Banff Highway Project

km 13 to km 27

Report of the
Environmental
Assessment
Panel

April 1982

Figure 2

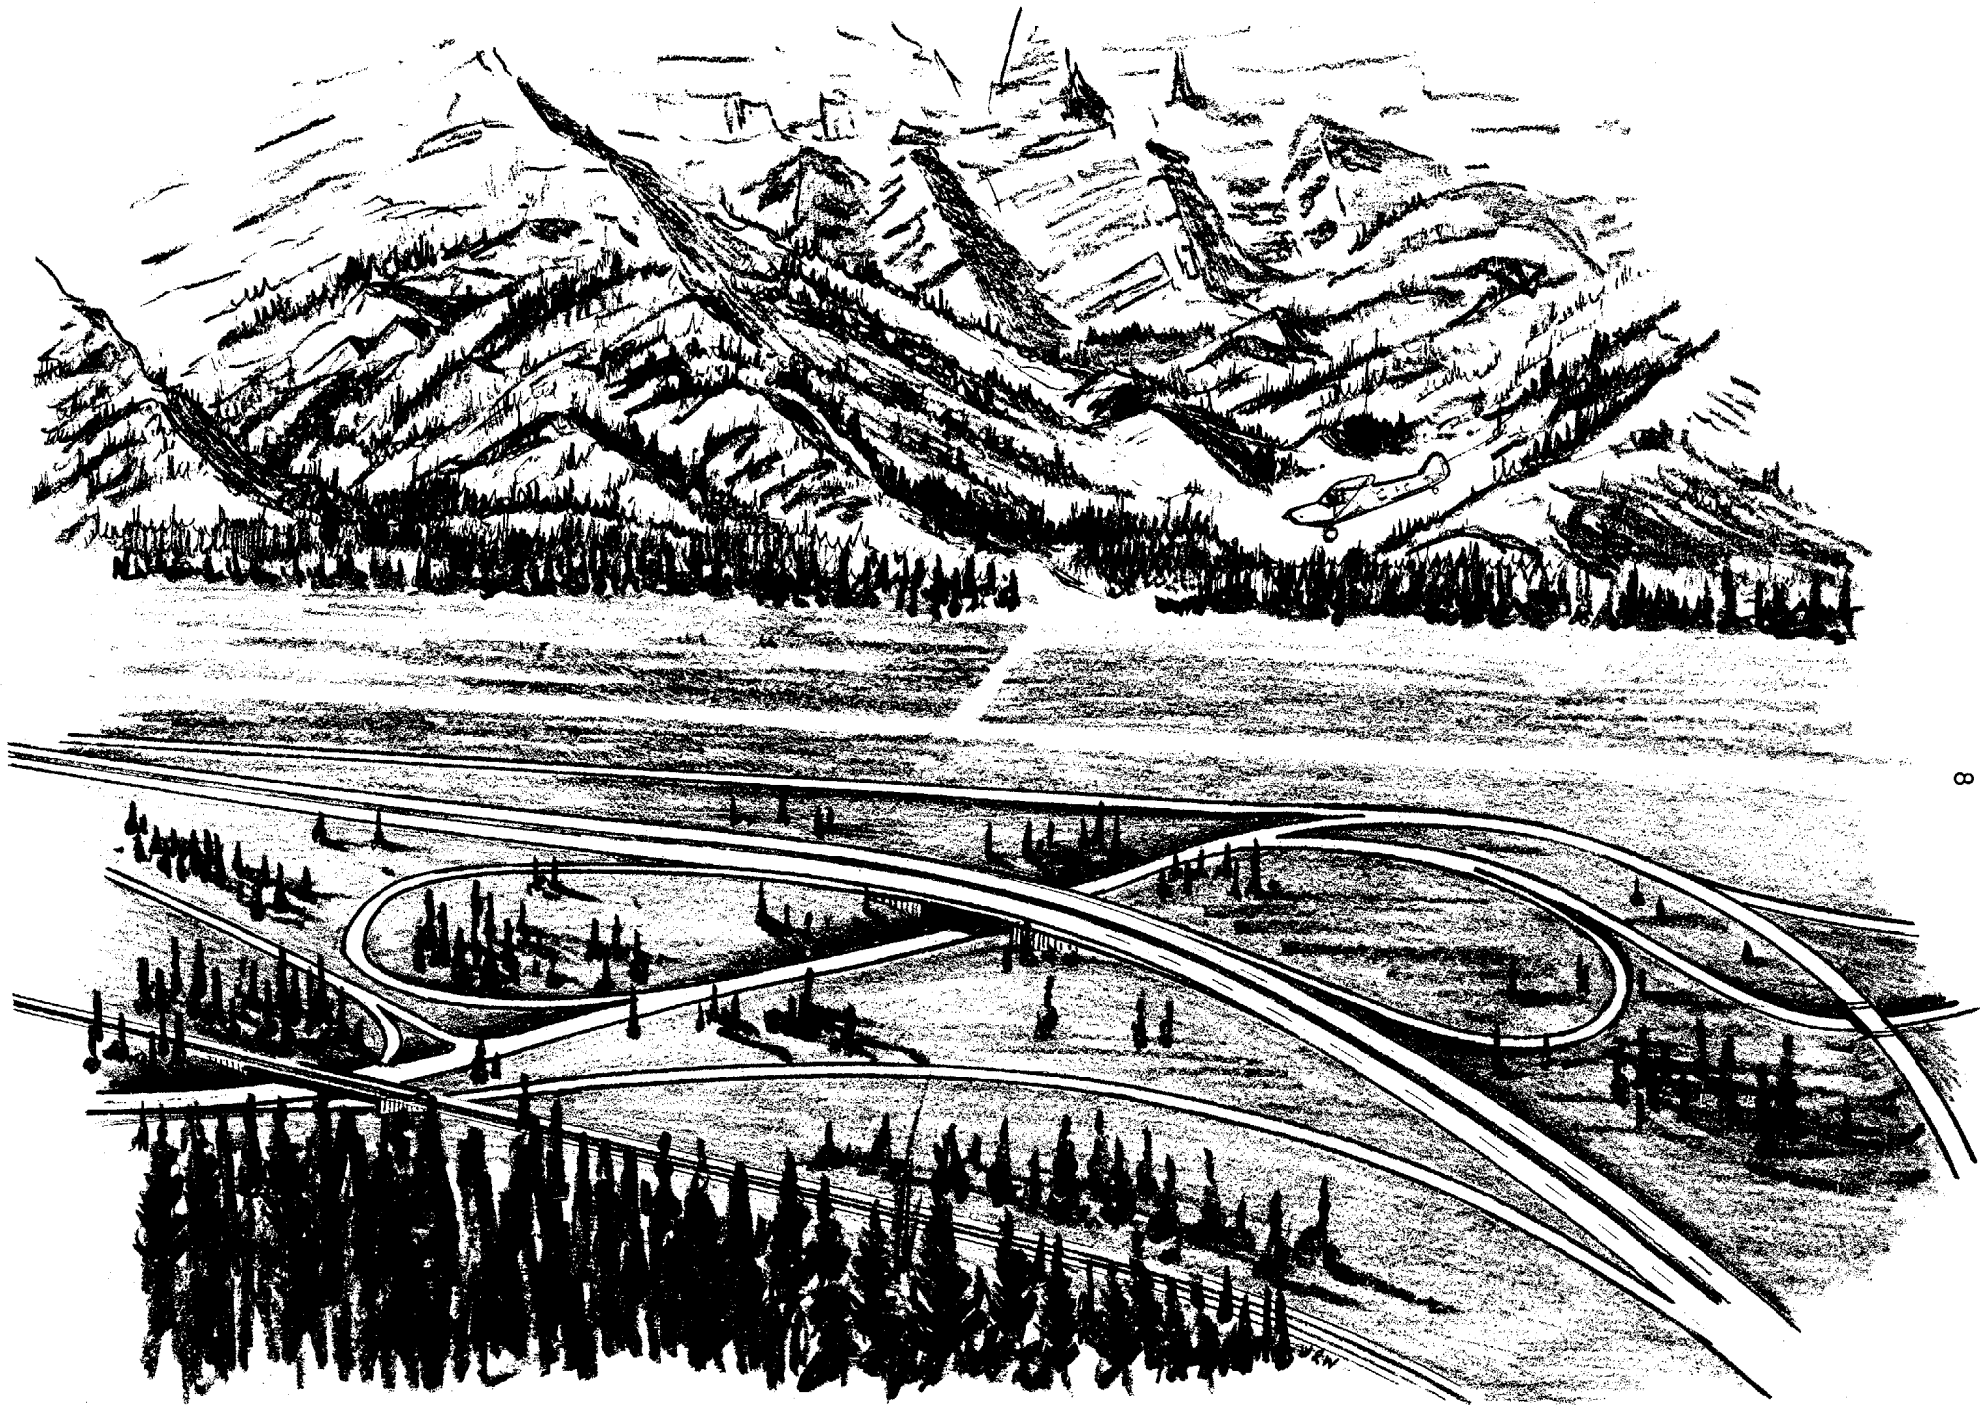
It is proposed to replace the existing Minnewanka traffic circle with a grade separated interchange (Figure 2). Banff town traffic would pass below the CPR right-of-way. A raised barrier median would be utilized through the interchange following which there will be a reversion to a depressed grass median. The proposed design would allow for the retention of the airstrip in its present orientation and location.

Virtually all intervenors supported the need for an interchange to replace the existing Minnewanka traffic circle although there were differences of opinion about the design.

- 1) the construction of a new interchange to replace the current Minnewanka traffic circle is considered an essential improvement, but that model testing should be conducted and the design adjusted, if necessary, to ensure a minimum of snow clearance problems;

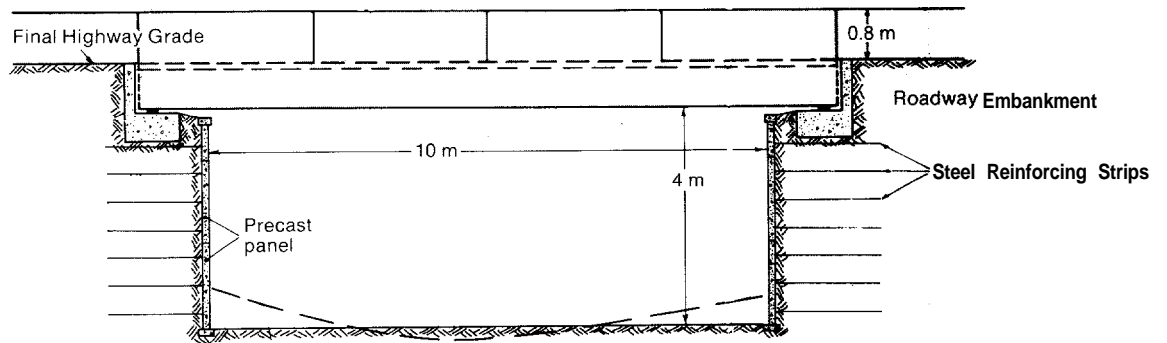
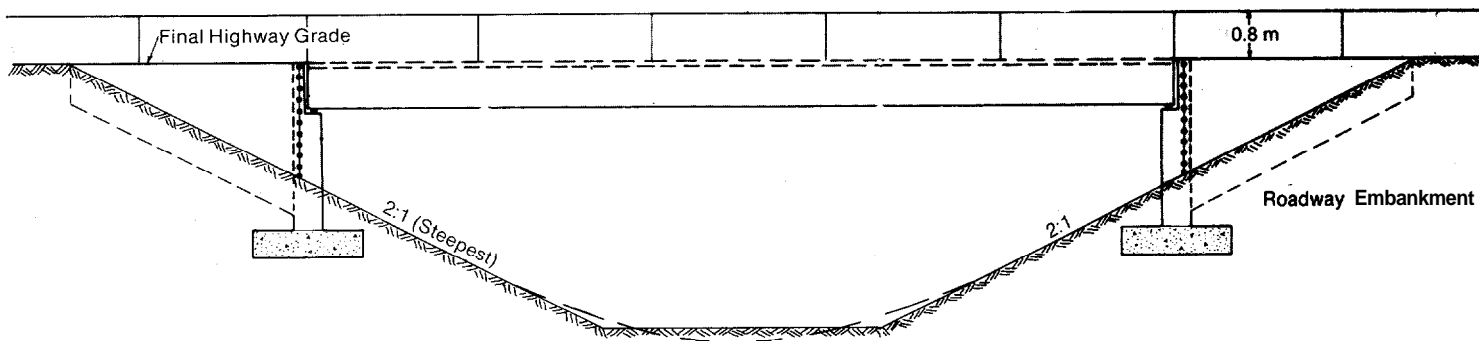
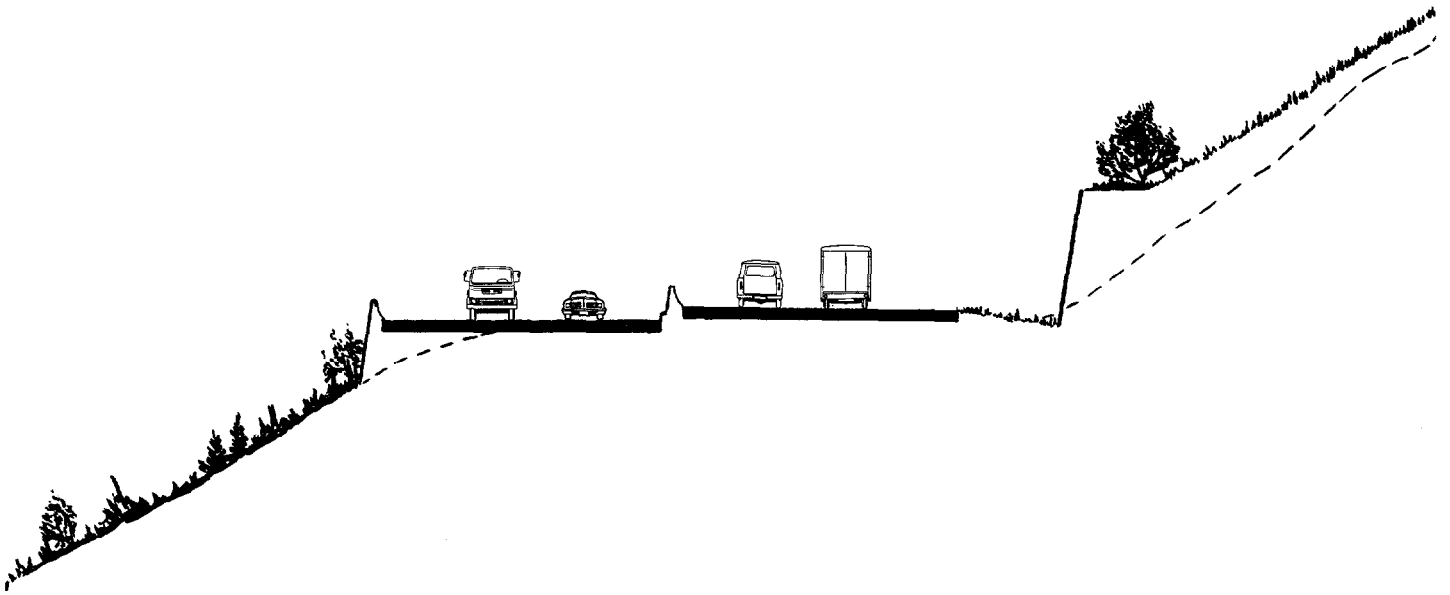
To permit wildlife crossing of the highway, Public Works committed itself to install five underpasses, one over-

pass and either another overpass or an underpass. The need to design the over and underpasses in a manner which would facilitate animal use was discussed. Open span structures with earth aprons were considered to be the best underpass design, but most costly. Other options for underpasses include a reinforced earth structure, and a culvert (Figure 5). An experimental large diameter culvert underpass is being installed at km 4 (Phase I).

Under and overpasses for wildlife use have not been tried in Canada, although underpasses have been used successfully in the Western United States. A number of intervenors recommended that because of the novelty of the technique and because of the wider range of species involved in the Park, an evaluation of their effectiveness in Phase I be completed before proceeding with them in Phase II. Public Works noted the use of existing bridges by ungulates and Parks Canada was confident that with conservative design the measures would work.

The Panel concludes that the impacts on wildlife of the proposed highway location and design could be contained within acceptable limits provided that proposed mitigation measures are implemented sensitively and effectively. However, further study is required to evolve the best design for the termination of fencing and, as experience is gained, some modifications to the over and underpasses may be necessary.

Figure 7

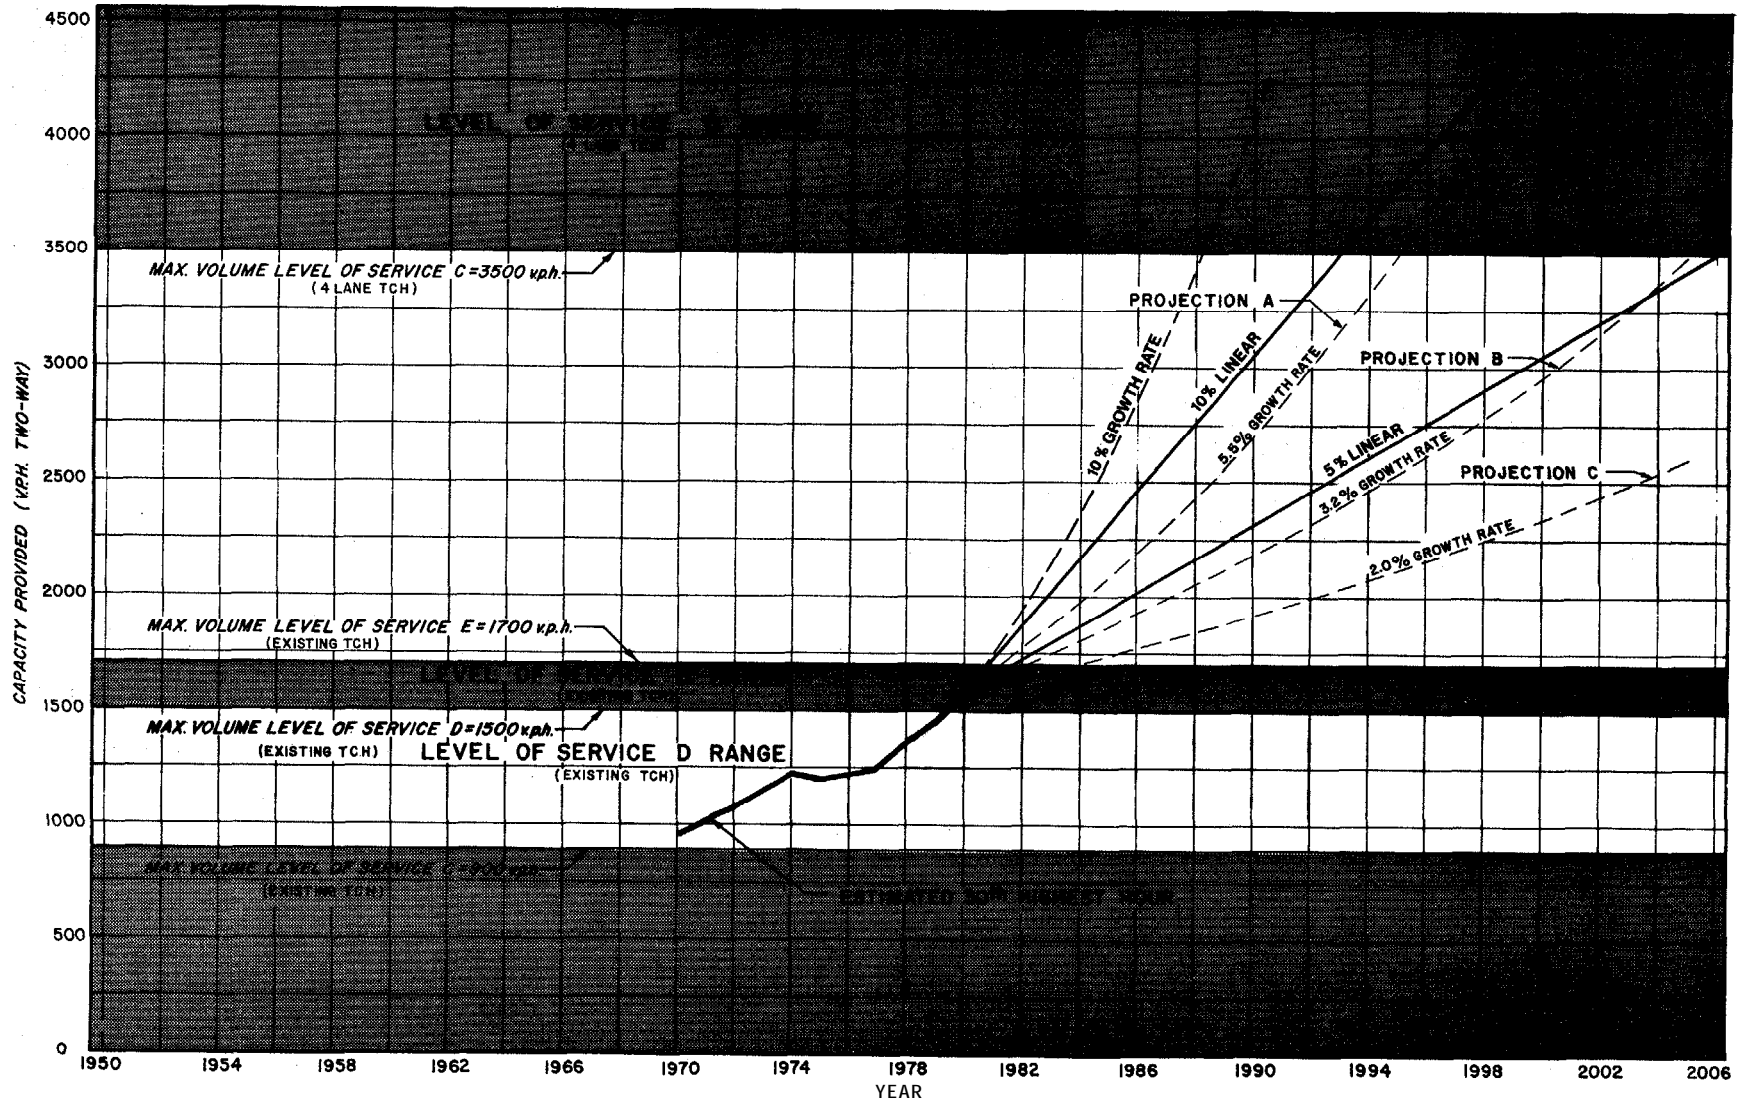
The proponent maintained that the results from using this approach indicate that the existing two-lane highway does not have the capacity at this time to provide a satisfactory level of service. If traffic continues to grow, the level of service would worsen causing an increasingly greater number of hours of congestion. Accordingly the proponent has recommended that the remedy urgently required is the provision of a four-lane facility, and, in the EIS, noted that the traffic volume at points on Phase II of the highway is over 90% of that on the Phase I stage, which is presently being twinned. Appendix F gives technical data on traffic analysis and levels of service.

During the Phase I review, the growth rate for traffic used by the proponent was questioned by a number of intervenors as being too high for a number of reasons including a possible gasoline shortage. It is interesting to note that the same growth rates were used for Phase II by the proponent but the general observation of intervenors this time was that if the growth rate continued as high as in the last few years congestion problems would

"All in all, the proponent has not brought forward any compelling argument that would indicate a decrease in travel demand resulting in a decline of the traffic growth trend from the current 10 to 13 per cent to 3.2 per cent annual growth. It may be a comfortable number to plan for, but will it materialize? What contingency plans should there be if it stays at the high level?"
